**ALL INDIA INSTITUTE OF MEDICAL SCIENCE
DR. B.R.A INSTITUTE OF ROTARY CANCER HOSPITAL
(STORE SECTION)**

T.NO.IR-04/IRCH/R.O/2024-25(CPP)

CORRIGENDUM

Corrigendum/Addendum- 1

There is no Construction Below the Bunkers (Only Foundation and Earth)

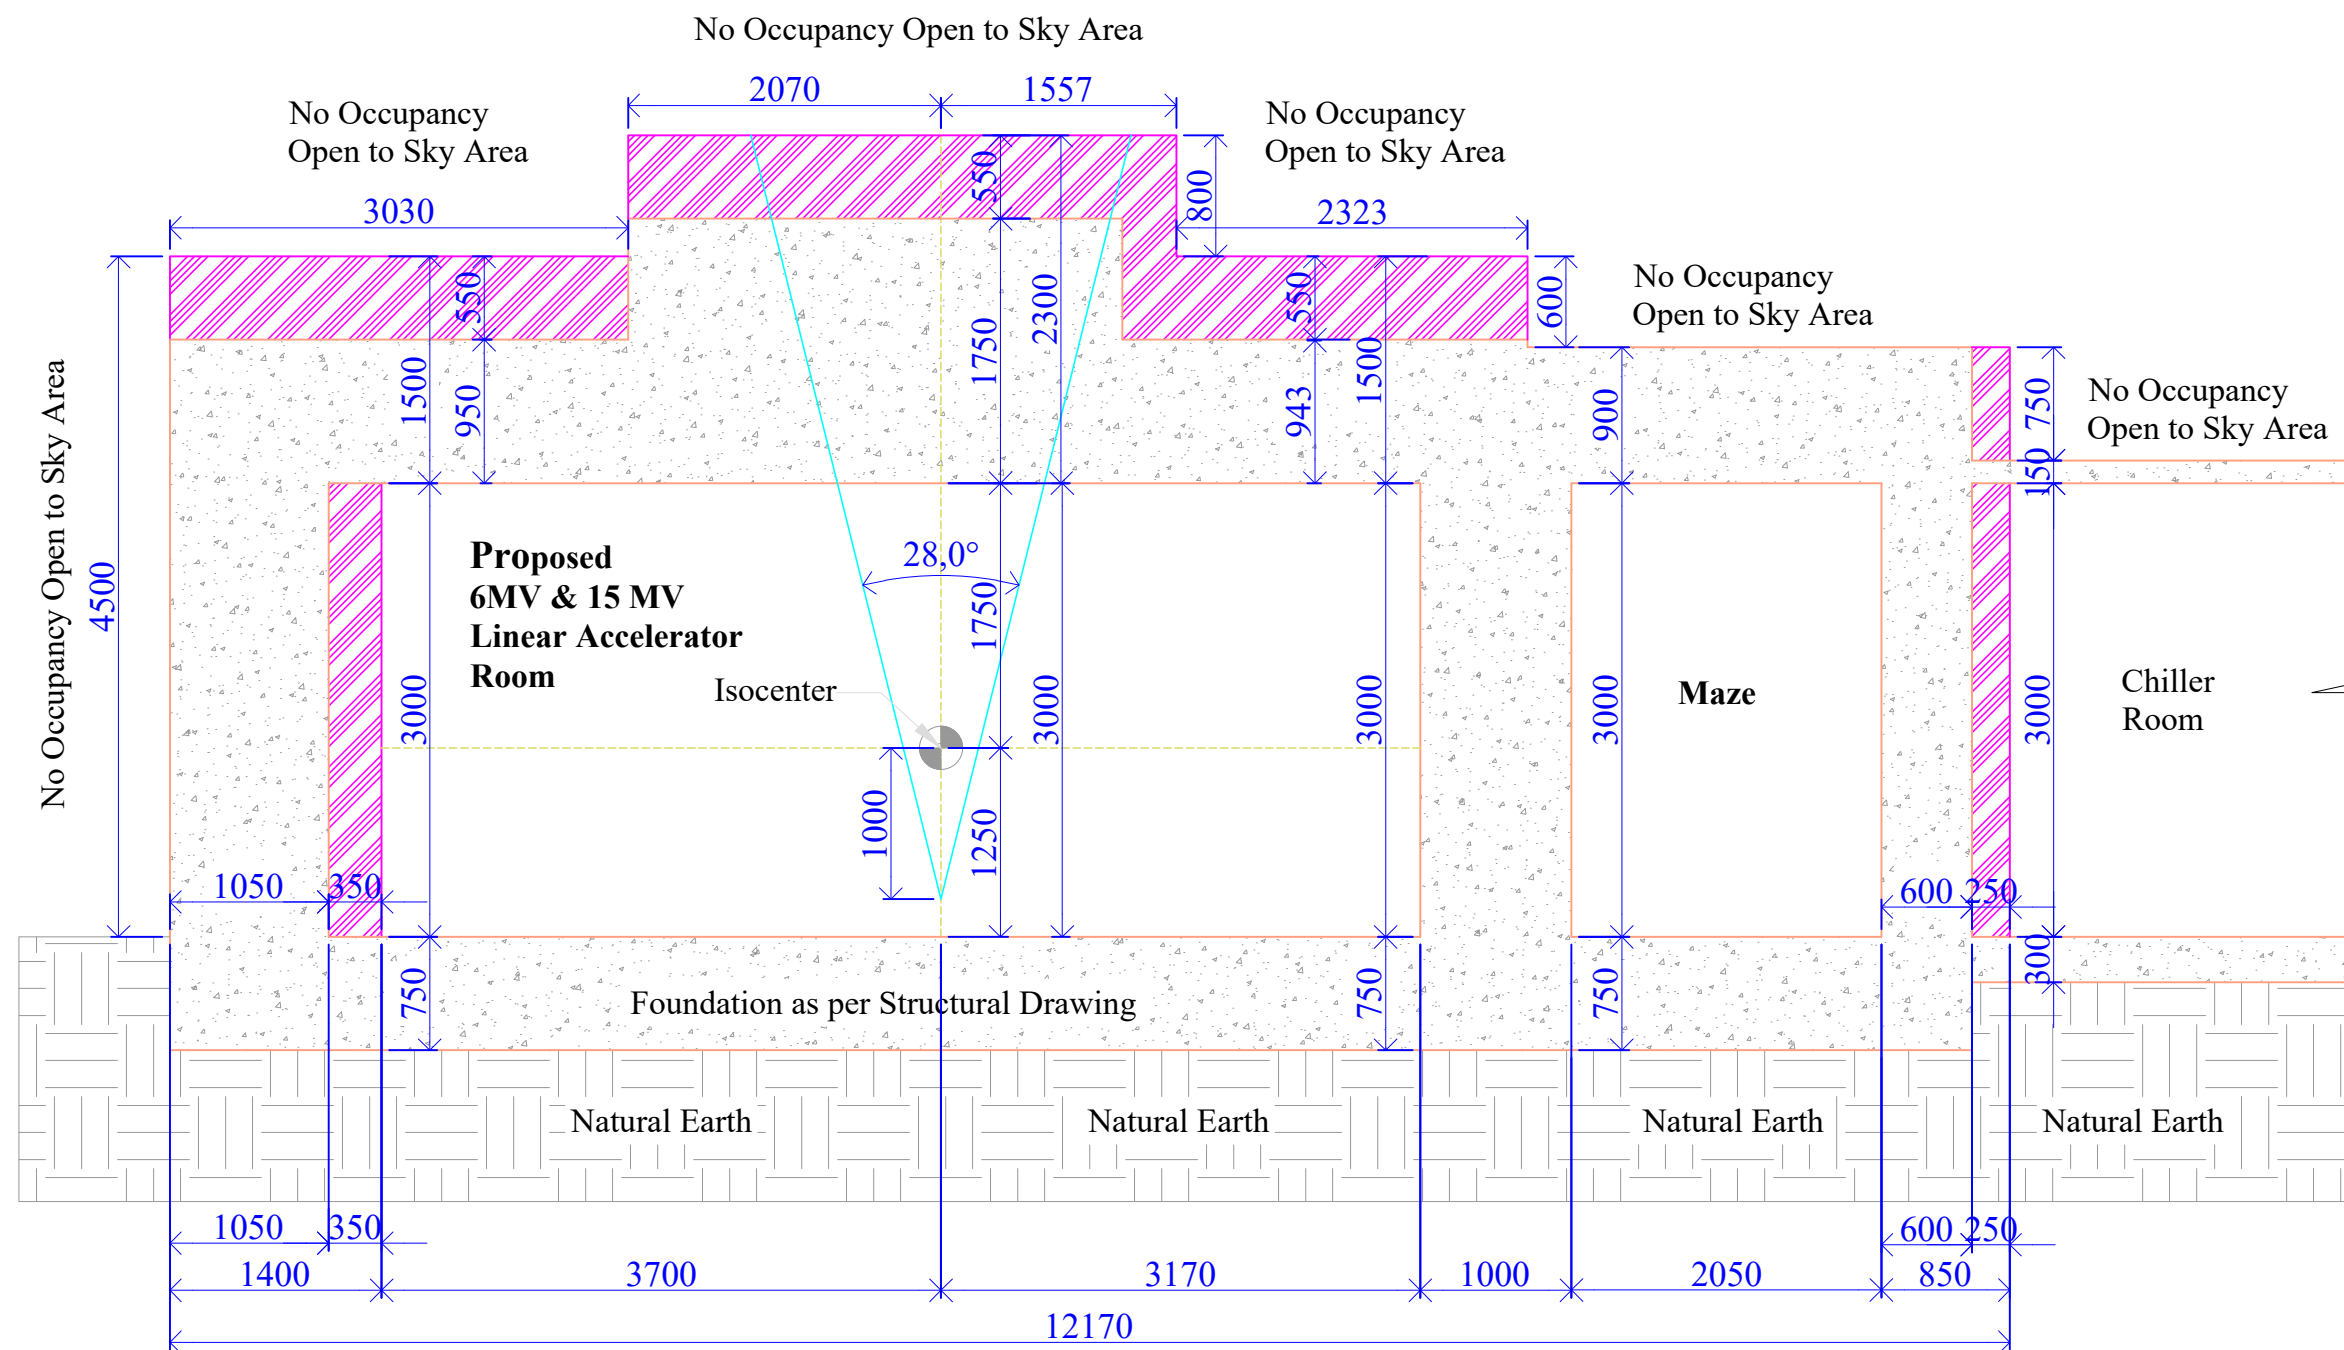
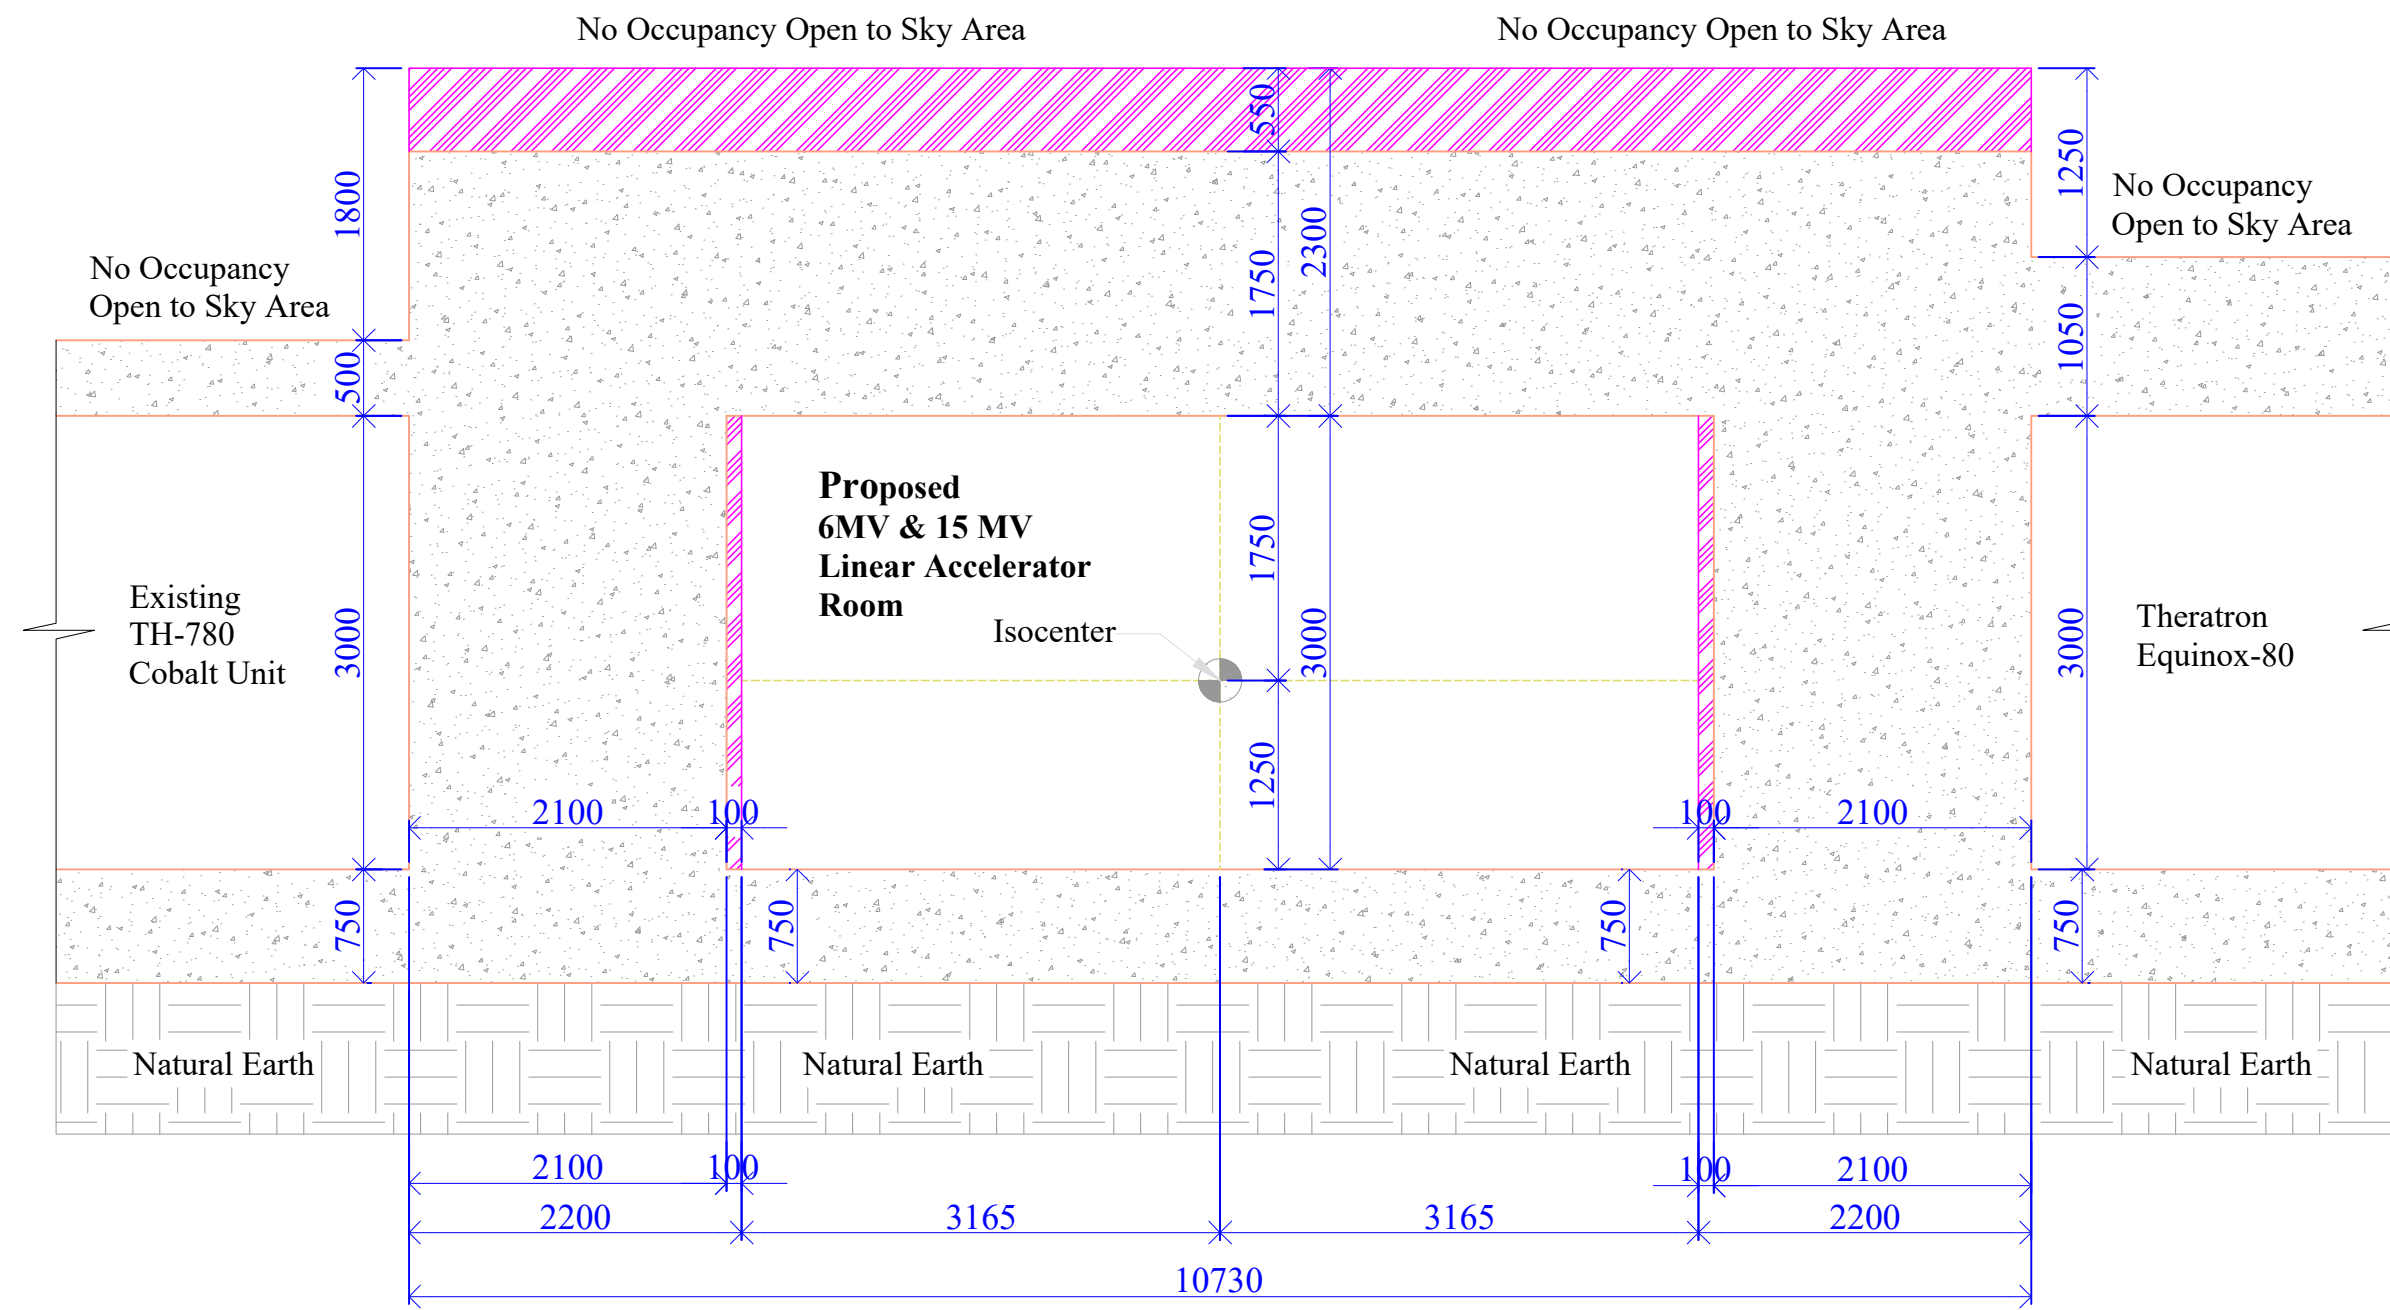
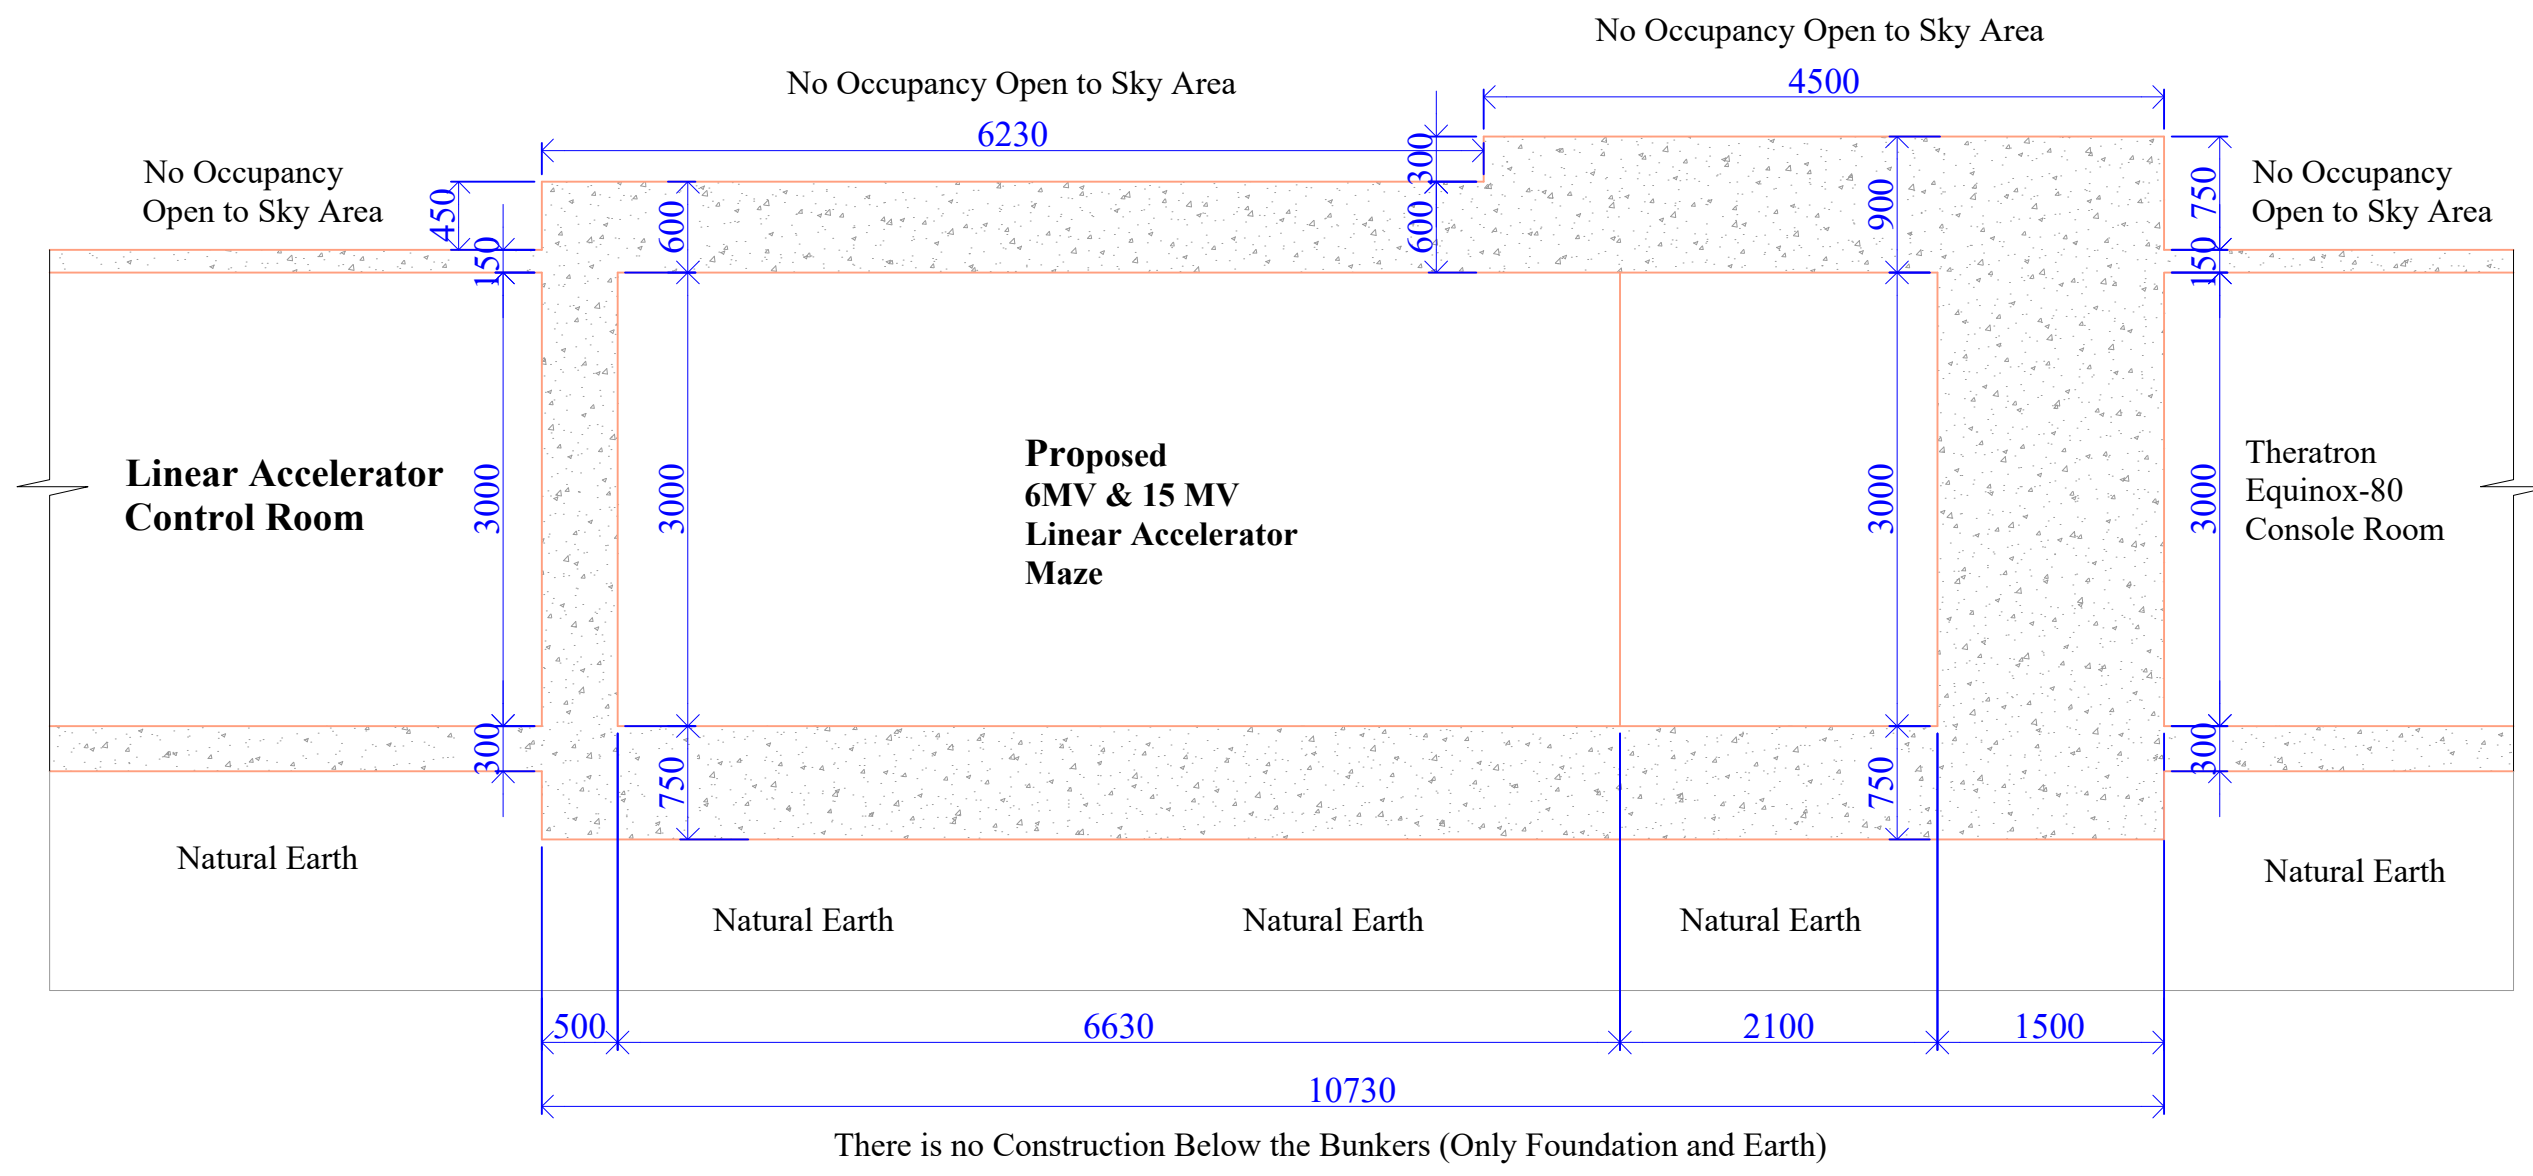
1	Point No.2 Page 78	2. The bunker / facility shielding work requirement is entirely the vendor responsibility. The successful vendor should do the necessary shielding works as per the AERB approved layout drawing and the same is given in the tender. The cost of the facility site modification work should be quoted separately, and this cost will be considered for L1 calculation.	2. The bunker / facility shielding work requirement is entirely the vendor responsibility. The successful vendor should do the necessary shielding works as per the AERB approved layout drawing and the same is given in the tender. The cost of the facility site modification work should be quoted separately, and this cost will be considered for L1 calculation. (i) The Chiller and UPS room for Linac bunker at Room No 9, Main RT, is at the room at first floor above the maze area as shown in sectional drawing (A-A) of the attached layout drawing. The TPS room is situated above the control console room of the proposed bunker. (ii) The Chiller and UPS room for Linac bunker at Room No 33, Ground Floor, DRBRAIRCH, are shown in room layout plan of the attached layout drawing. The TPS room is situated at room number 34 & 37, Ground Floor, DRBRAIRCH.

5.	Page 83-87;	Attached drawings	The legible layout drawings in pdf format are attached.
Dosimetry Items :-			
		Relative Dosimetry Equipment	
1	Page No. 73, Sr. No. 1	Radiation Beam Data Acquisition System 3D scanning water phantom of square /rectangular shape for linear accelerator beam commissioning dosimetry and annual QA. The system shall have automatic setup for beam center adjustment and auto field alignment capability. The system shall consist of 3D scanning water tank, lift table, water reservoir, electrometer / controller, beam data acquisition software with latest laptop computer, two approximately 0.125cm ³ or equivalent water-proof ionization chambers and associated holders and cables.	3D scanning water phantom of square /rectangular/cylindrical shape for linear accelerator beam commissioning dosimetry and annual QA. The system shall have automatic setup for beam center adjustment and field alignment capability. The system shall consist of 3D scanning water tank, lift table, water reservoir, electrometer/controller, beam data acquisition software with latest laptop computer, two approximately 0.125cm ³ or equivalent water-proof ionization chambers and associated holders and cables.
